ALASKAN WAY VIADUCT

EVALUATION OF GRAY'S RETROFIT PROPOSAL

Prepared for the
Washington State Department of Transportation

By
T.Y. Lin International

Figure 16 Column curvature versus axial force, retrofitted structure, rare earthquake, middle bents

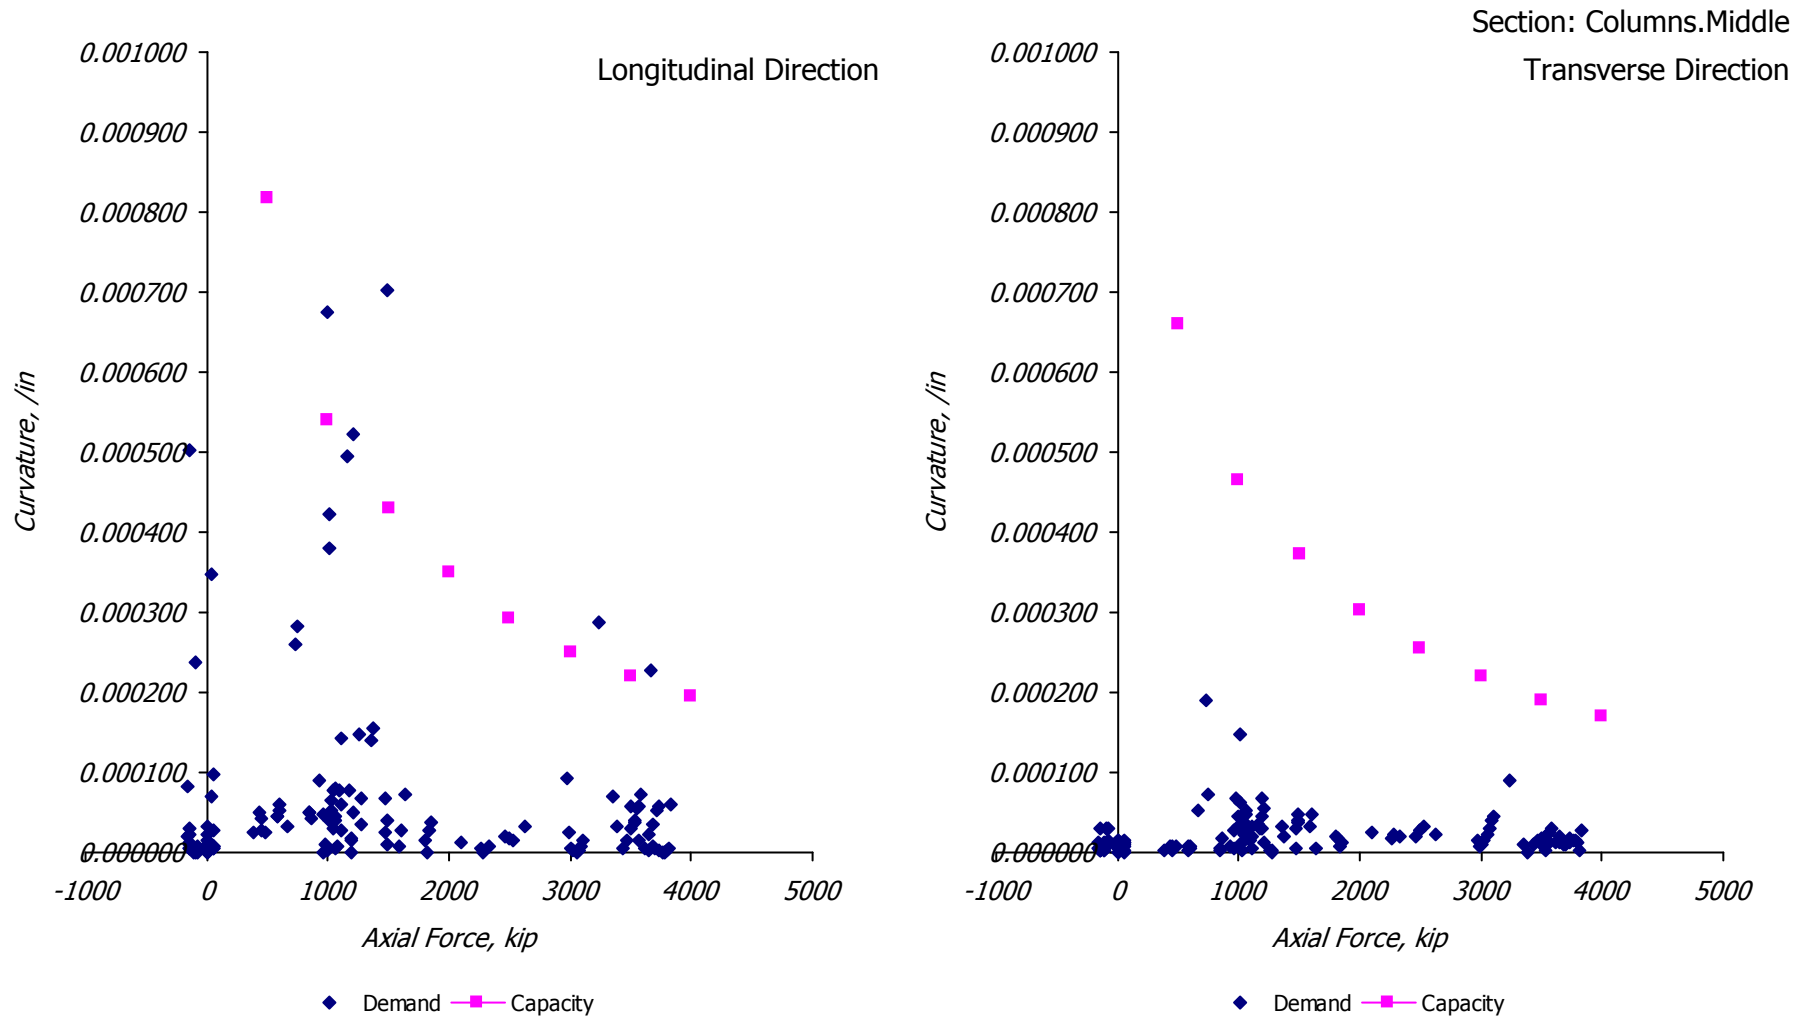
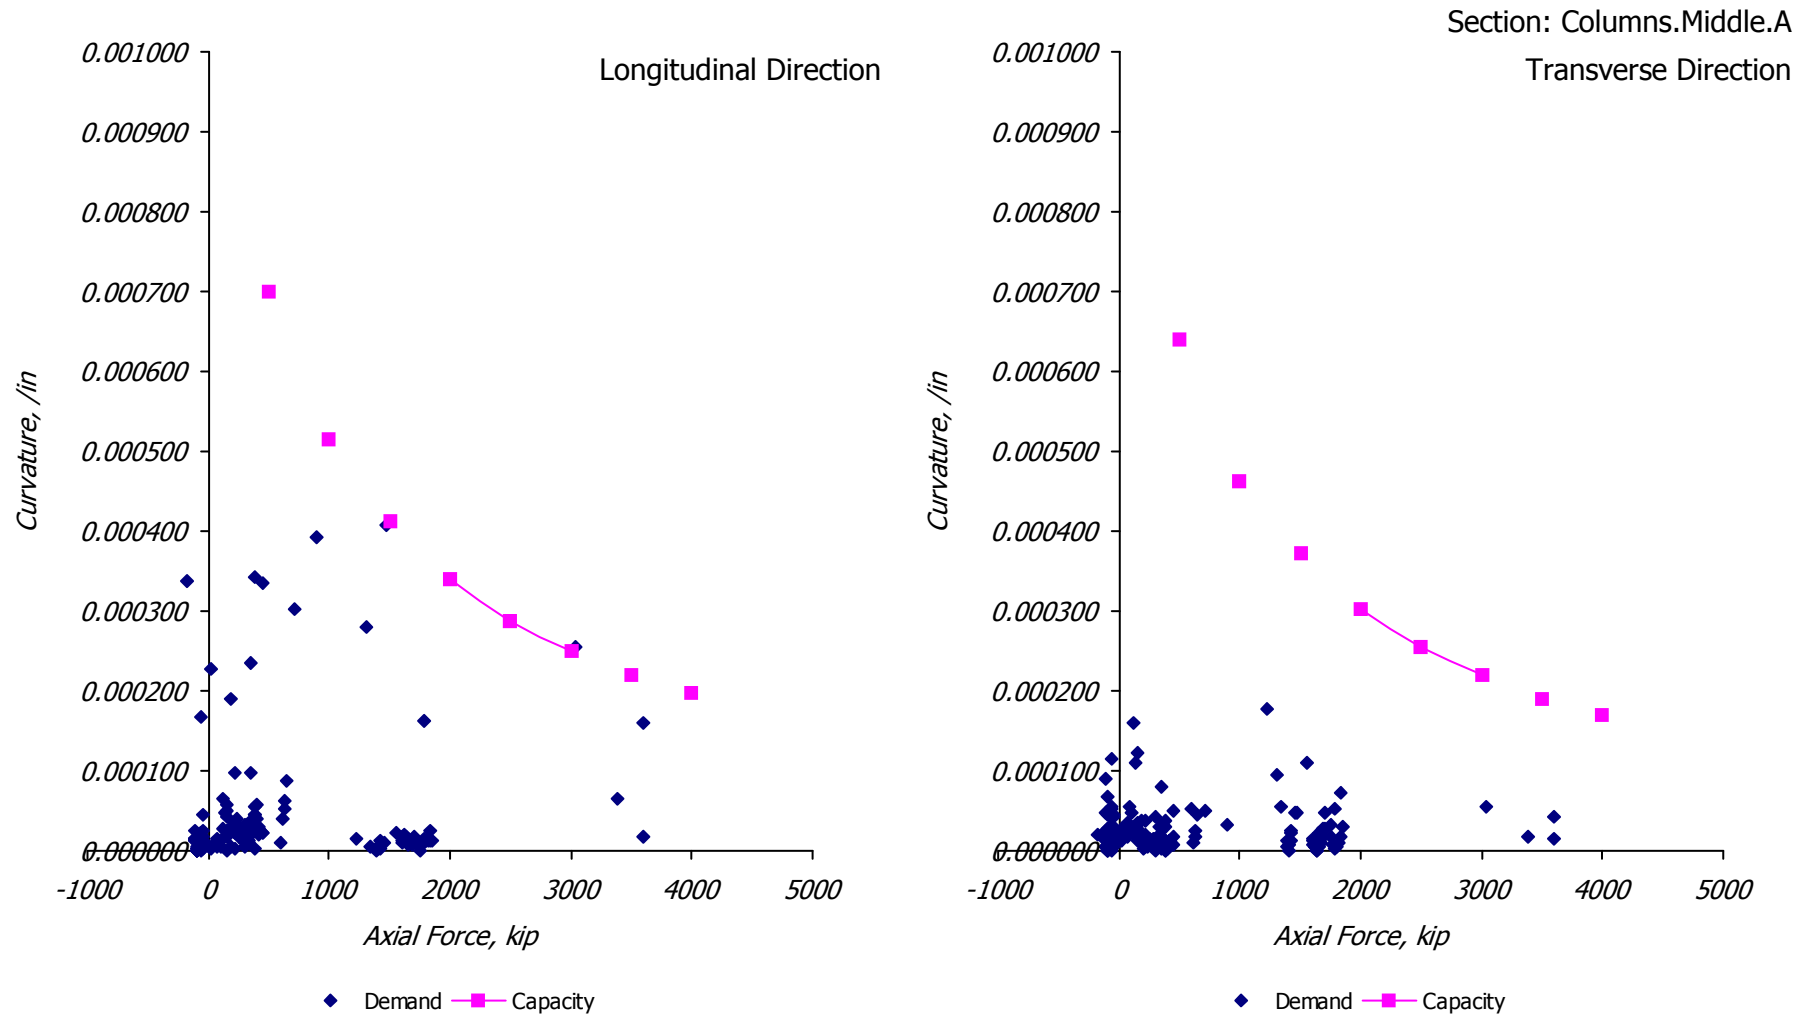
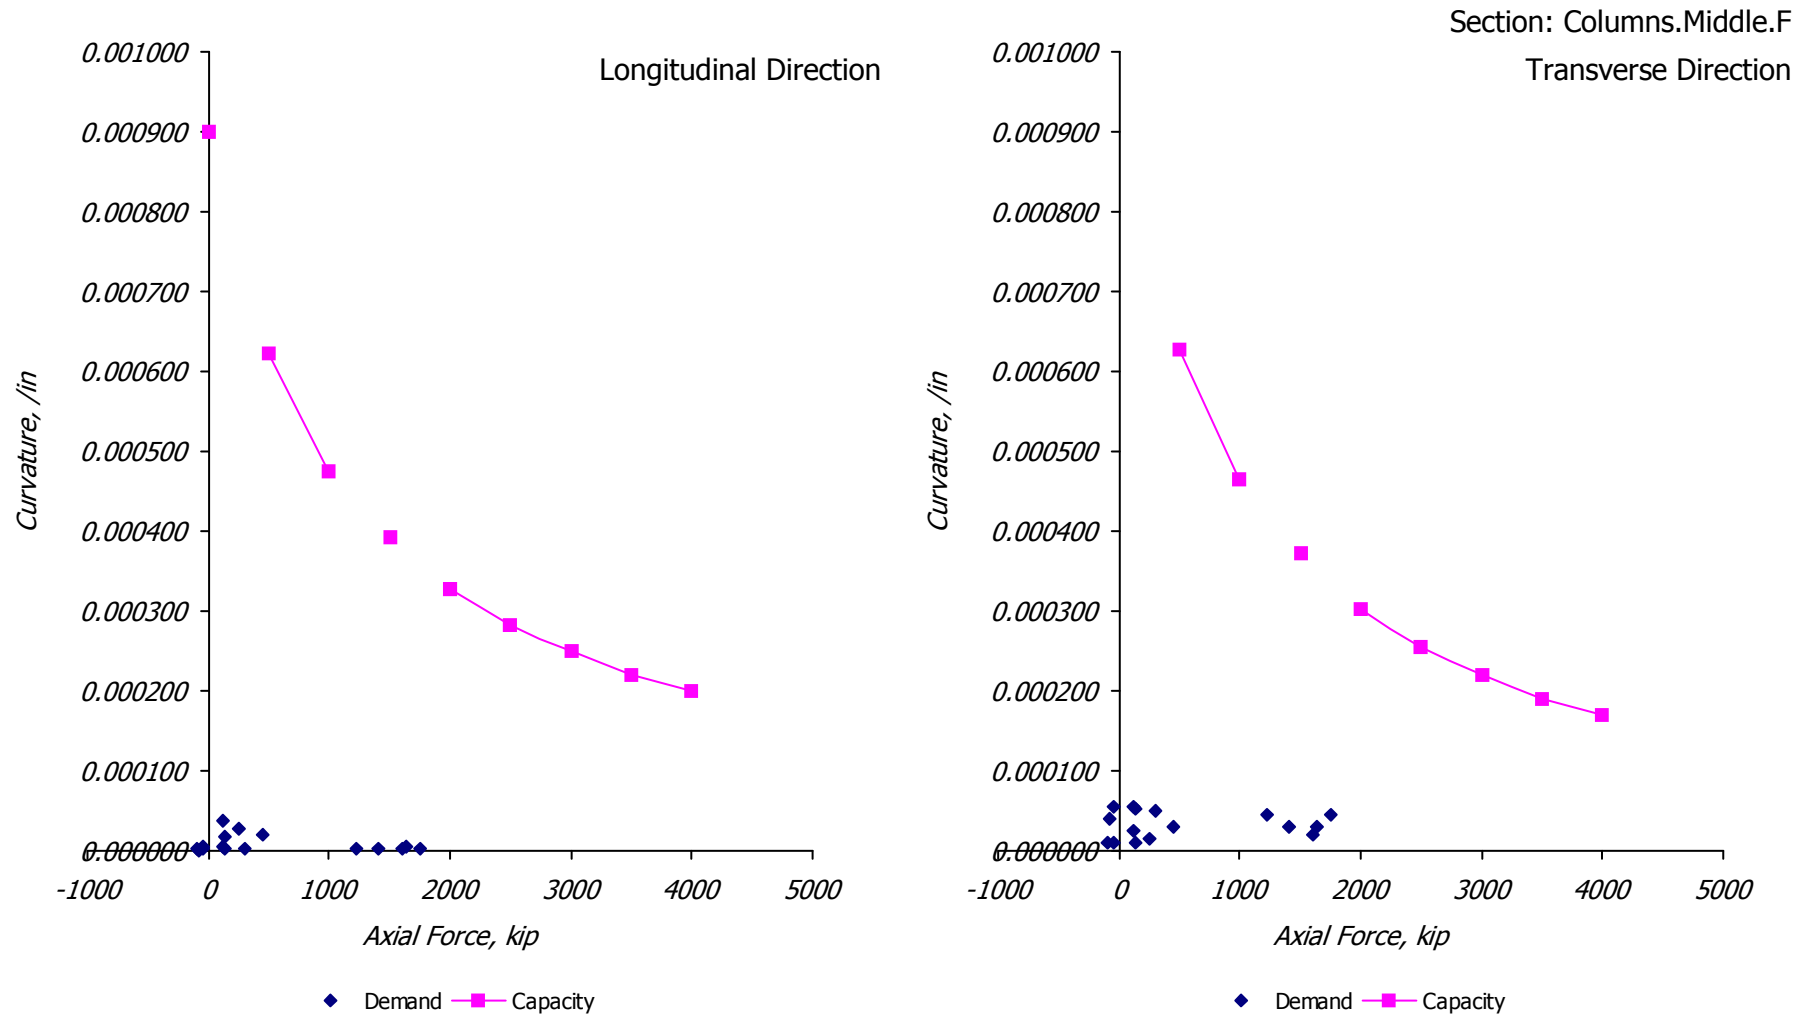
Figure 15 shows that the flexural demands on the end columns slightly exceed the capacity in the transverse direction, for the section designated "Columns.End" (the typical section). Figure 16 shows that the flexural demands on the middle columns slightly exceed the capacity in the longitudinal direction, for the section designated "Columns.Middle" (the typical section). A closer look reveals a more insidious problem, however. The axial forces on the middle columns are very high, over 3500 kip, which is equivalent to a stress of about $0.4f'_c$. These forces are caused by rocking of the structure and impact of the columns and footings against the piles.

sults are shown in Figure 16. The Mathcad analysis also shows that the column response at high axial load levels is brittle. Catastrophic column—and viaduct—failure would ensue if the curvature capacity was even slightly exceeded. The results shown in Figure 16 indicate that the structure would collapse in a rare earthquake due to combined flexure and axial forces caused by rocking and impact.

Figure 17a

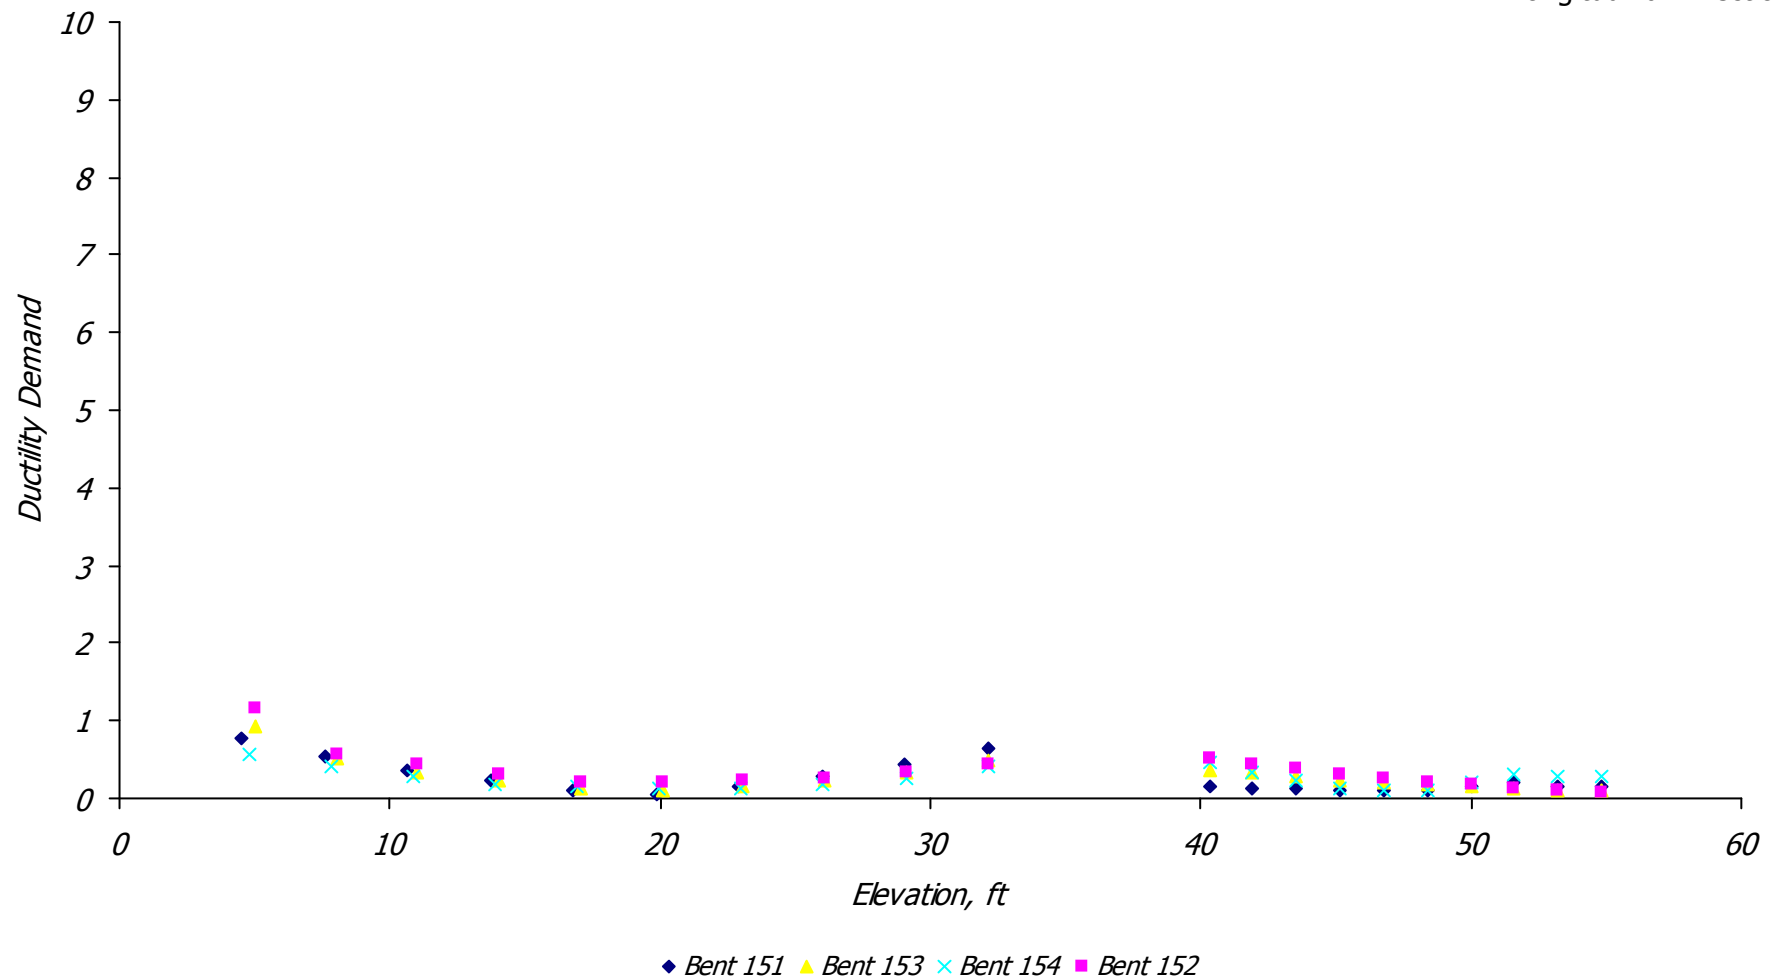
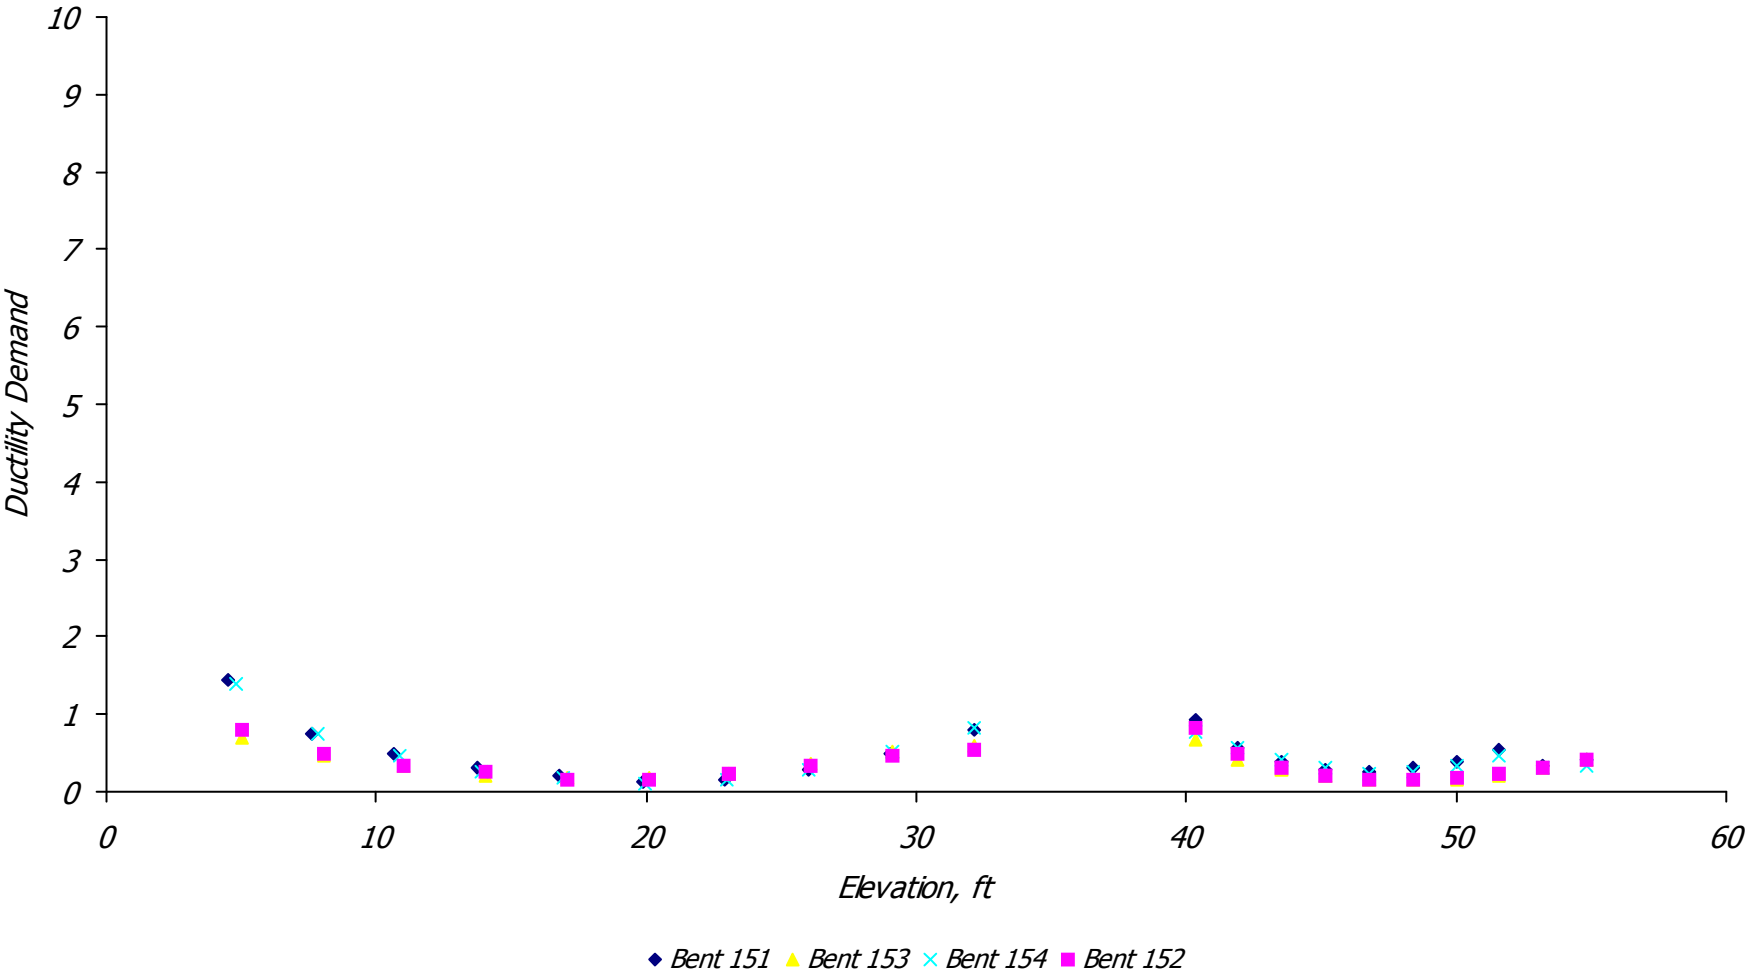
For the design earthquake, the curvature ductility demands on the columns are summarized in Figure 17. The largest values only slightly exceed unity, so damage should be repairable.
